Net Zero Teesside Project

The Net Zero Teesside Order

Consultation on Proposed Changes to the Net Zero Teesside DCO
Application

Date: 10 March 2022

Figure 2-1 Location of Work No. 2A: Option 2 (Sembcorp Pipeline Tie In)

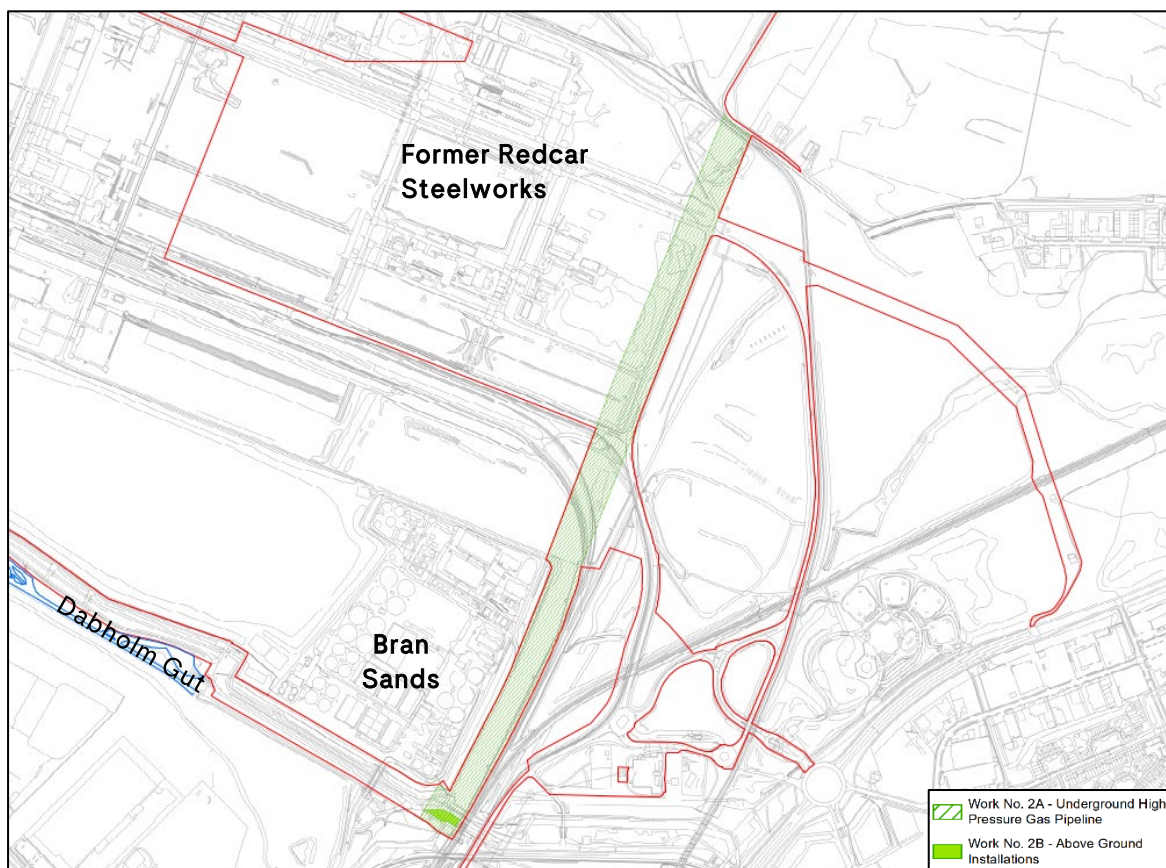
- **Option 2 (Sembcorp Pipeline Tie-In):** the outlet from a new NZT AGI would be fed into the existing, disused 24" Sembcorp gas line which runs through North Tees. The existing Sembcorp pipeline crosses the River Tees and lands on the north bank of Dabholm Gut and runs on to the Wilton site on South Tees. At a point near the Bran Sands Wastewater Treatment Plan (WwTP), a new tie-in would be constructed which then connects via a new AGI into a new gas pipeline which would run to the PCC Site via a wayleave to the east of the Bran Sands WwTP.

2.1.5 During the period from May 2021 to February 2022, a combination of further engineering studies, on-site assessments and landowner and asset owner engagement has enabled the optionality for Work No. 2A to be refined, with the results of these refinements shown in **Figure 2-1** below. The Applicants propose to select Option 2 (Sembcorp Pipeline Tie-In). The route of the tie-in pipeline and associated AGI are shown in Figure 2-1.

Figure 2-2 Location of Work No. 6 Options 2 (Indicative HDD Trajectory) and 3 (Sembcorp No. 2 Tunnel)

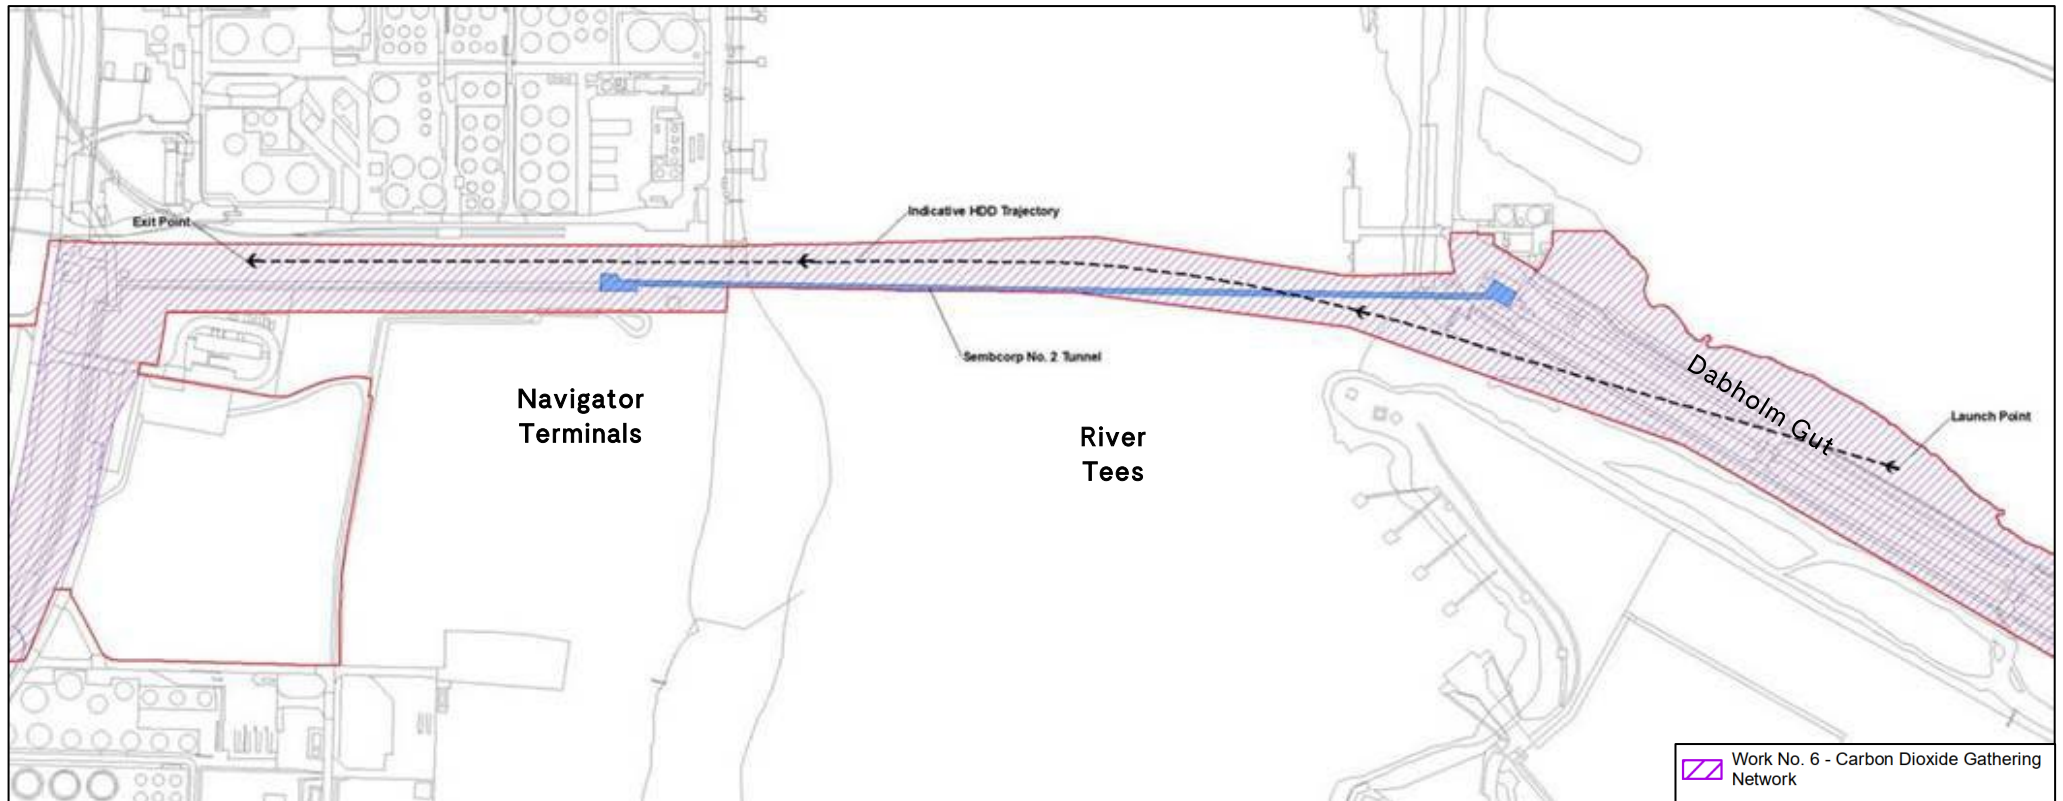
- 2.1.10 The proposed changes therefore comprise two revised options for the CO₂ Gathering Network's crossing of the Tees (see **Figure 2-2**) below:
- **Work No. 6 Option 2 (HDD and connection via Dabholm Gut):** the option of an HDD bore will remain within the DCO Application. However, a changed trajectory for the HDD bore used to allow the pipeline to cross the Tees now necessitates changing the direction that the HDD will be drilled and the pipeline pulled from; and

- **Work No. 6 Option 3 (Sembcorp No 2 Tunnel):** this is a new option that makes use of existing infrastructure in an existing Tunnel across

the River Tees that is located within the existing corridor for the CO₂ Gathering Network (the 'Sembcorp No 2 Tunnel').

- 2.1.11 Further detailed engineering assessments have been carried out for the HDD across the River Tees. These have taken into account landowner, design and operational constraints in the area, current and future plans, plus existing asset infrastructure. The engineering study work has demonstrated to the Applicants that the HDD routing trajectory needs to be changed and that as a result of the trajectory change the launch site for the HDD now needs to be on the south side of the River Tees on land to the north of Dabholm Gut (previously it was on Navigator Terminals land to the north of the Tees). The exit point is now expected to be north of Navigator Terminals land (on land still within the Order Limits).
